**ADDENDUM NUMBER 02**

**Project No. 22009 / 23007**  
**Sandusky County EMS**  
**Life Squad Station 14 / SCEMS Administrative Offices & Life Squad Station 18**

This Addendum supplements and amends the original Drawings and Specifications dated **October 24, 2024**, and shall be taken into account in preparing bids and becomes a part of the contract documents. Note: this addendum information is issued to bidders of record. It is the prime contractor's responsibility to forward this Addendum information to all affected suppliers and sub/contractors and make adjustments relative to the proposal. Bidders should acknowledge receipt of Addendum on Page BF-1 of the Bid Form, or the last page of this Addendum.

1 FIRST FLOOR PLAN  
A2.1 1/4" = 1'-0"

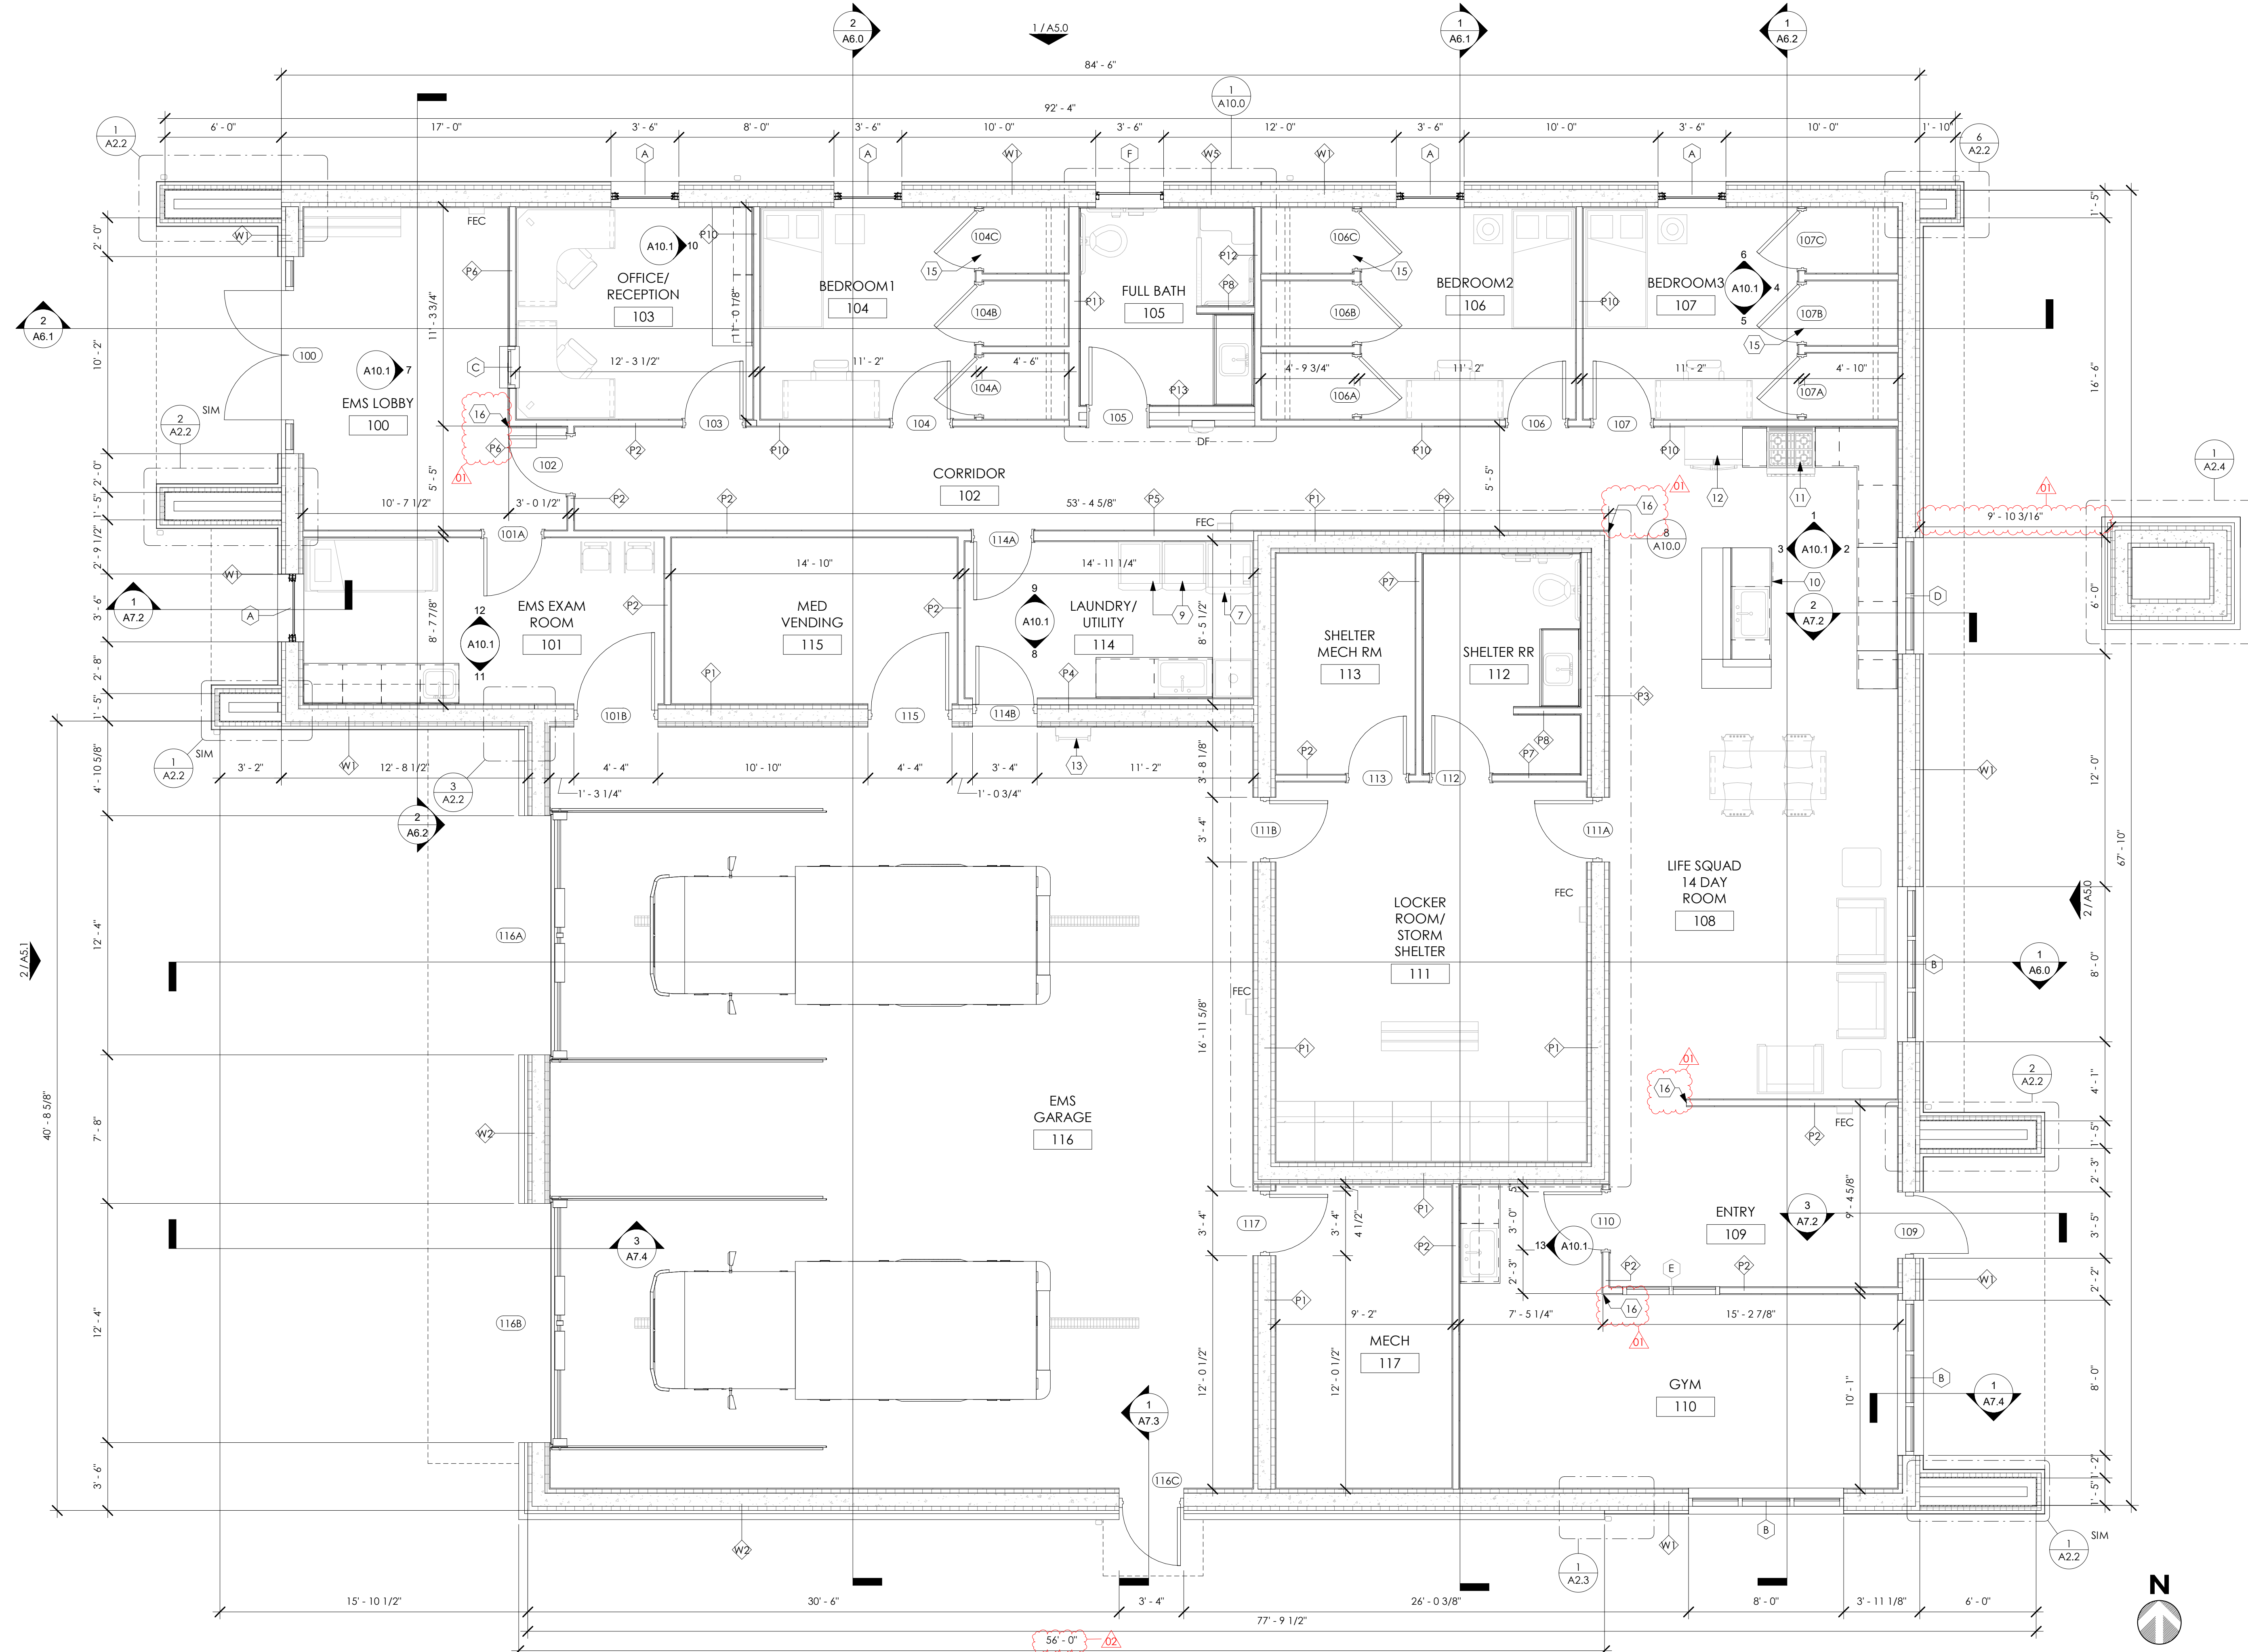
a. Plan 1/A2.1:

- i. Added masonry dimensions to south wall south wall for brick veneer.

**Q:** On sheet A2.1 (First Floor Plan), there are currently no dimensions for the brick veneer walls for the south and east wall. There are some dimensions for the walls themselves, but not specifically for where the brick veneer starts and ends. Could dimensions be added so that scaling is not necessary?

**A: Please see updated sheets A2.1 and A4.0 for added masonry dimensions for the brick veneer.**

1 ROOF PLAN  
 A4.0 3/16\"/>

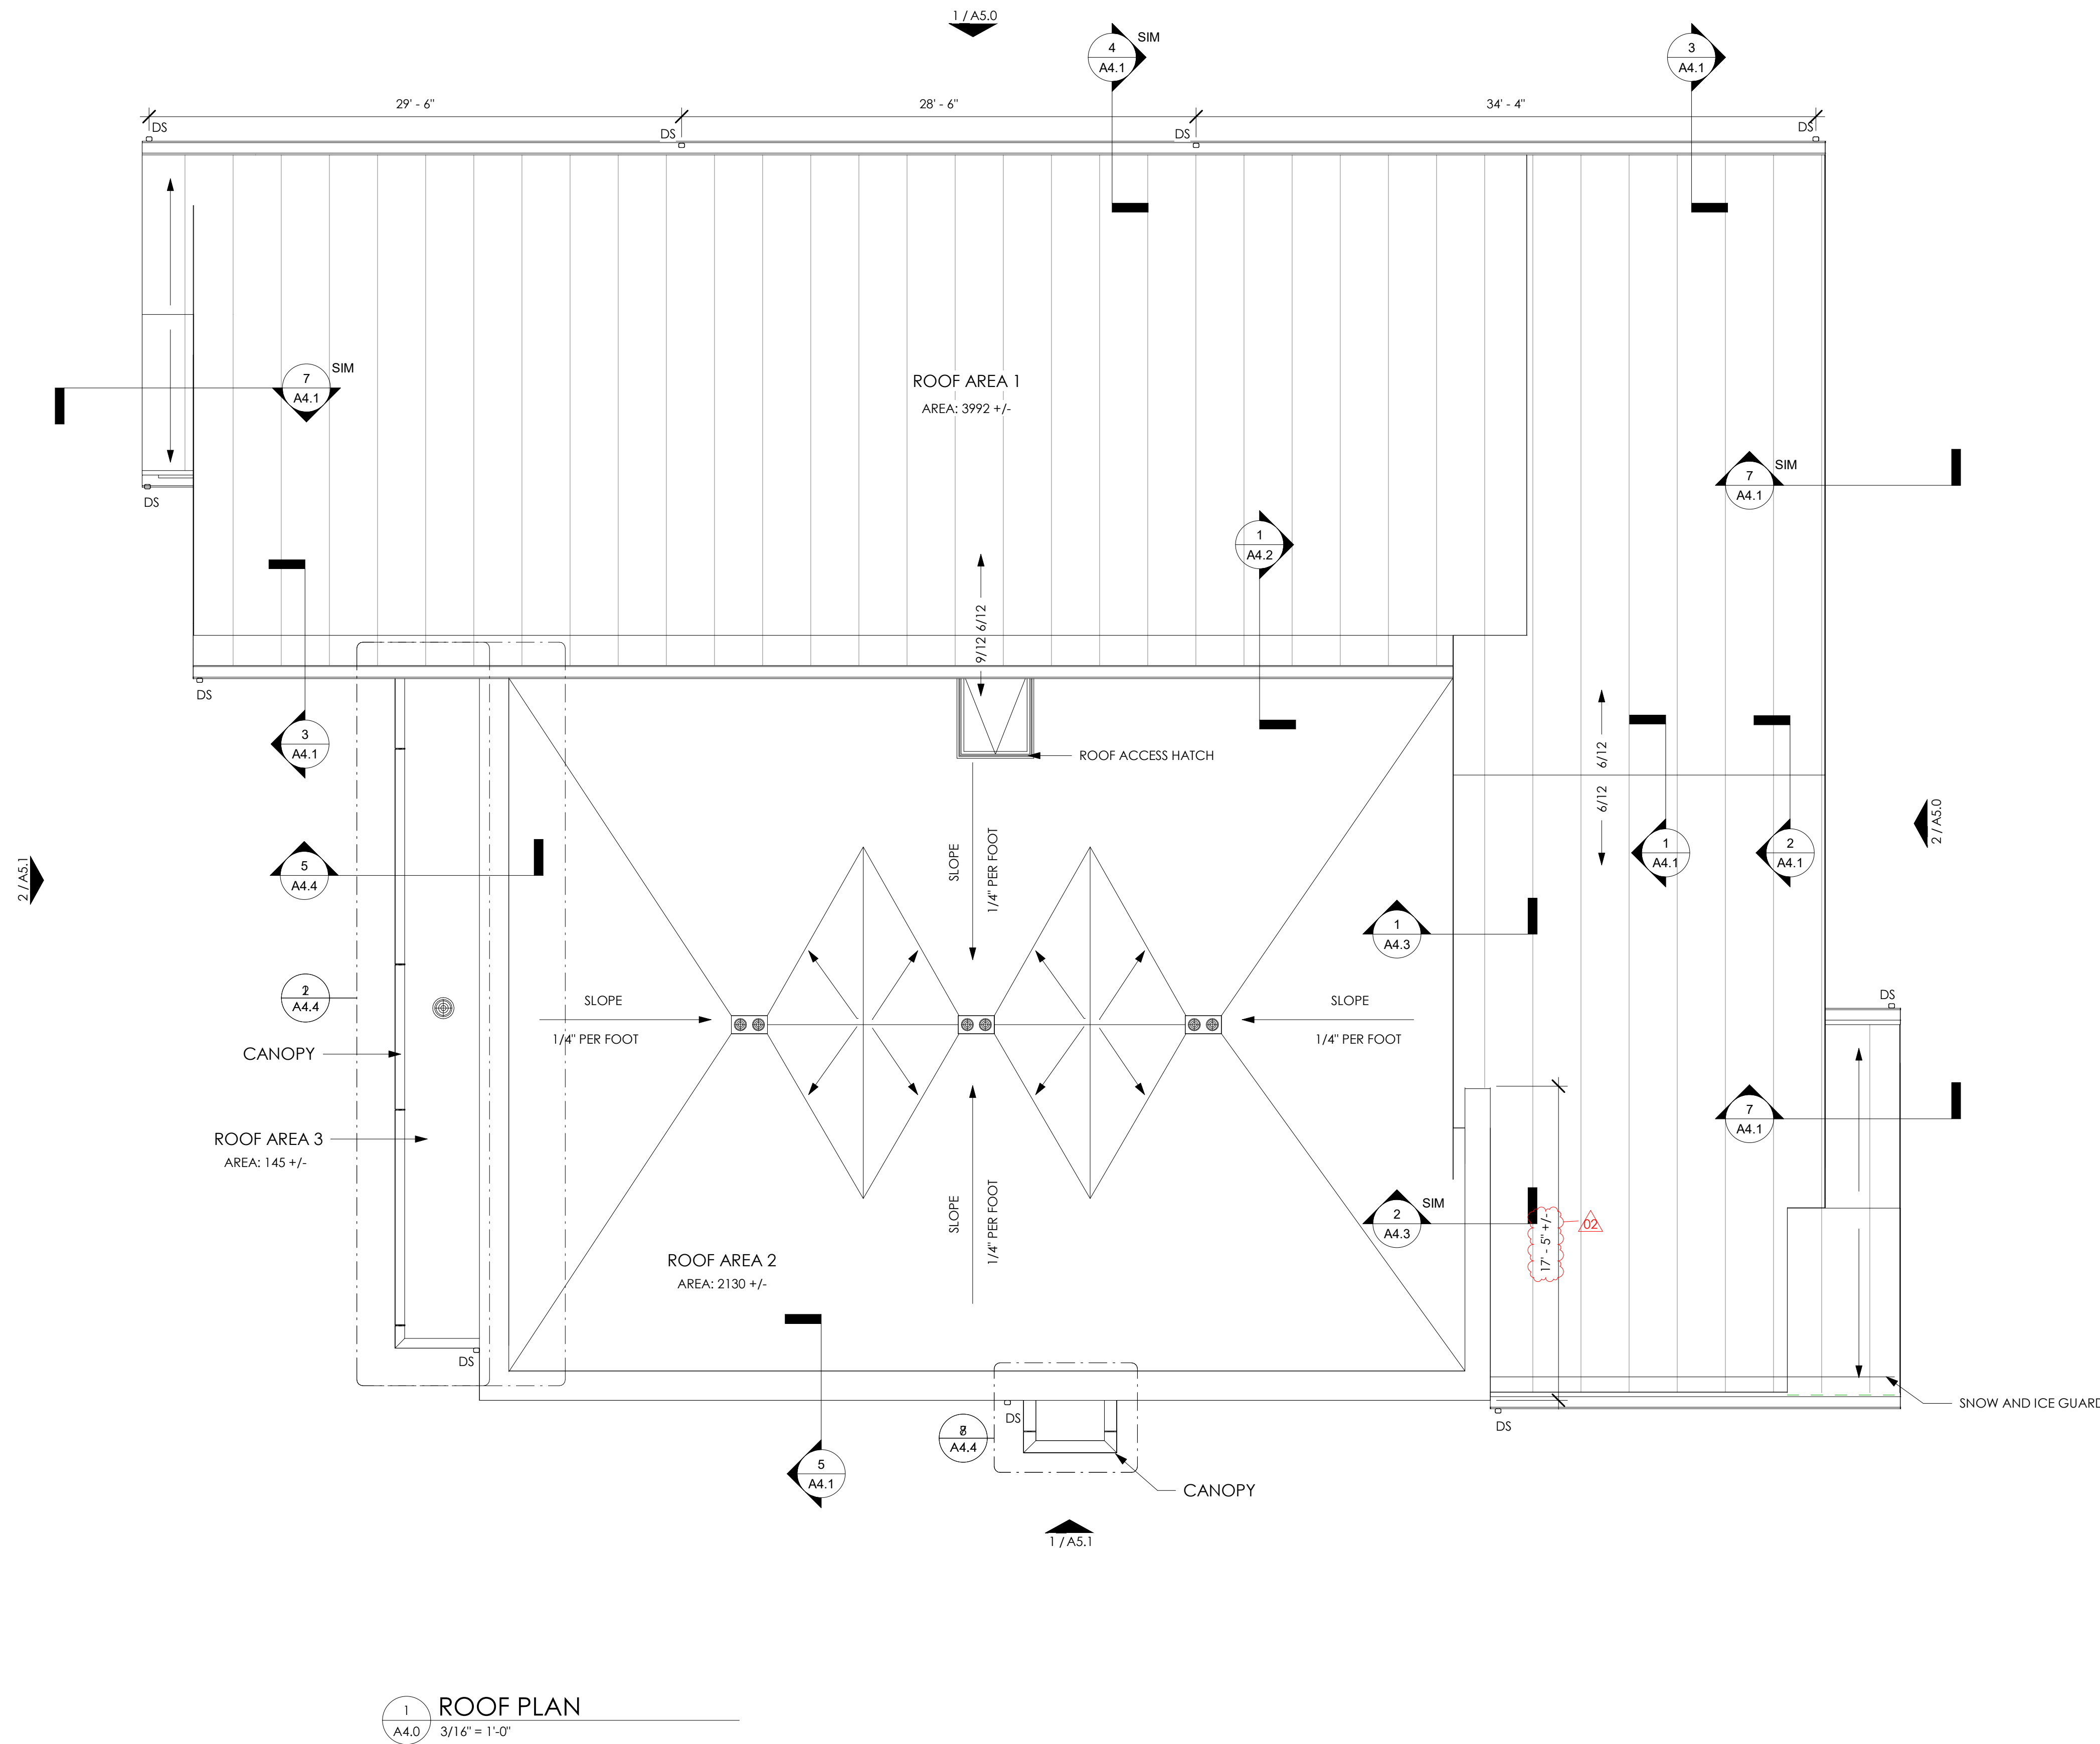
a. Plan 1/A4.0"

- i. Added masonry dimension on east garage parapet wall for extents of face brick.

**Q:** On sheet A5.0 (Exterior Elevations), the east elevation shows brick veneer on a wall that is further back. If you then go to sheet A2.1 (First Floor Plan), there is no wall shown, no dimensions to go off of for the brick veneer, and no wall sections through this wall. Could dimensions and a wall section be added for this wall?

**A: This brick veneer wall is above the gable roof, its base slopes along the roof. Please see sheet A4.0 for added dimensions of this wall. See detail 2/A4.3 for wall section information on this wall.**

**10 RECEPTION/OFFICE**  
A10.1 1/2" = 1'-0"

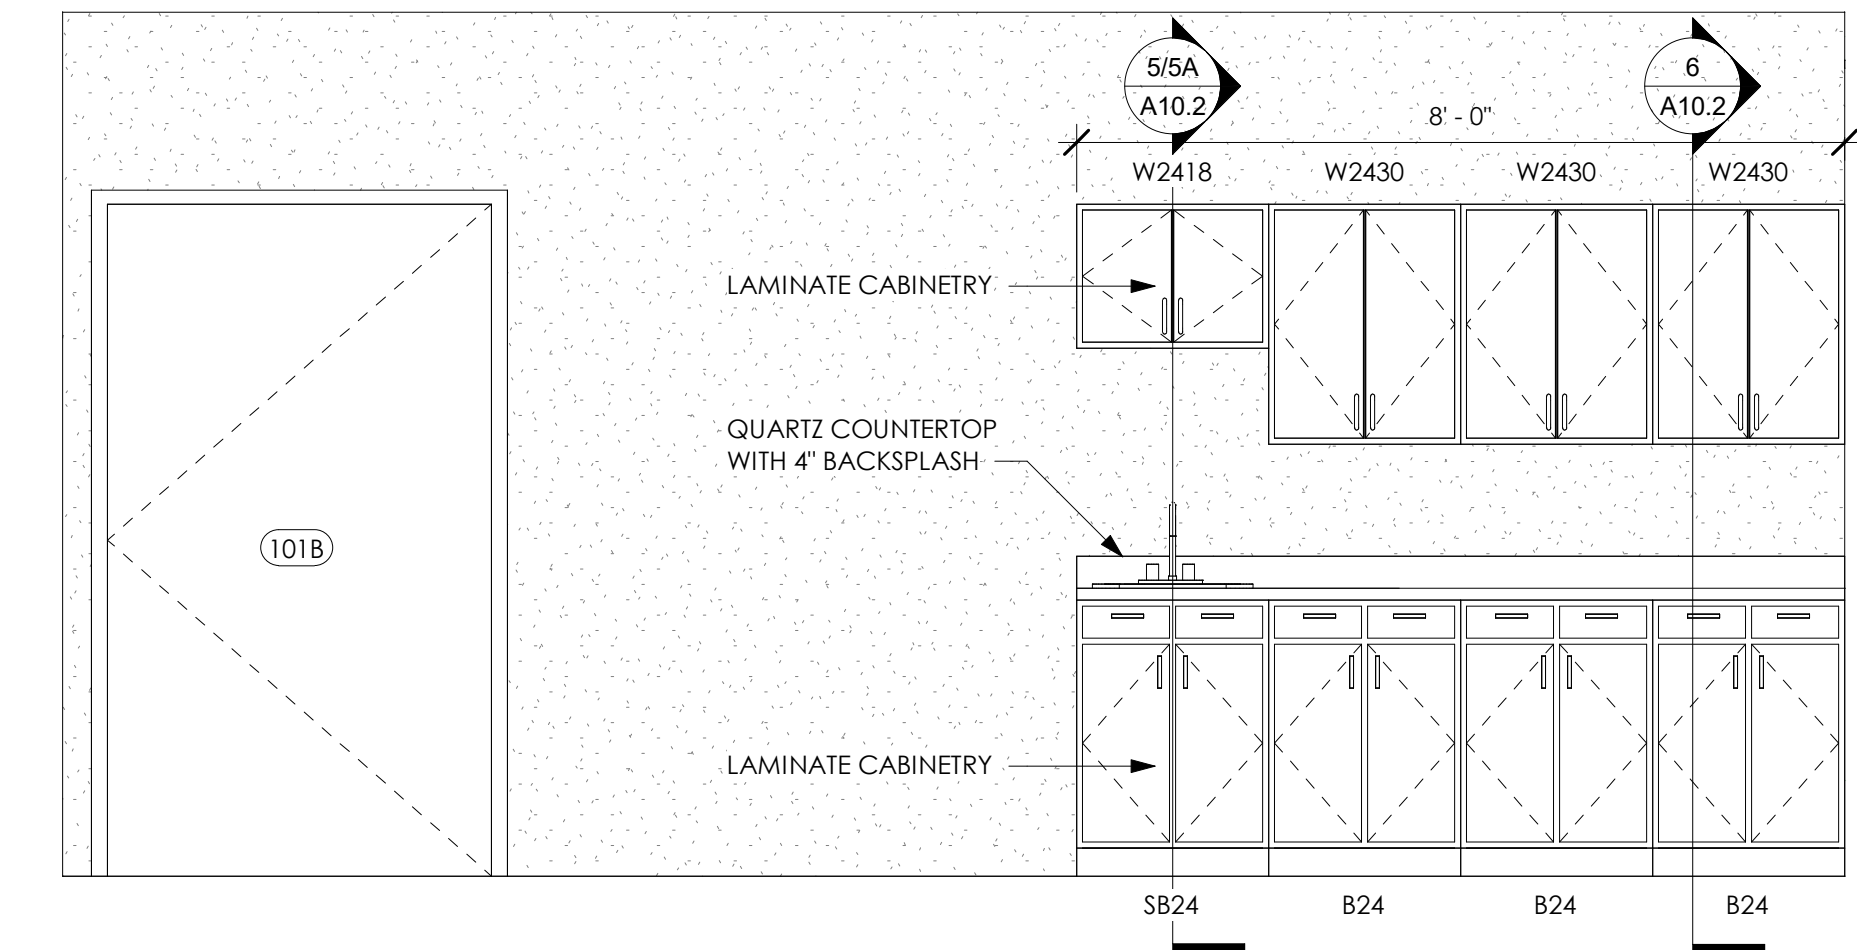
3. **A5.1**
  - a. **Elevation 2/A5.1**
    - i. Added keynote material tag "B2" for upper portion of brick veneer wall
4. **A9.0 (REISSUED)**
  - a. **Door Schedule: Doors 116A / 116B**
    - i. Door material changed to Insulated Steel.
    - ii. Door Frame material changed to Galvanized Steel.
  - b. **Door & Frame Elevations: Revised elevation 4 for OHD.**
5. **A10.1 (REISSUED)**
  - a. **Elevations 10 & 13 added.**

**Q:** On Addendum 01, Page 17 – This is in the Squad 14 section. This seems to be for 18, but does the same cabinetry apply to 14 Reception area? Did not see revised 10.\* drawings for 14. See reference Q & A below:

**A: Interior elevations 10 & 13 have been added to sheet A10.1 for life squad 14.**
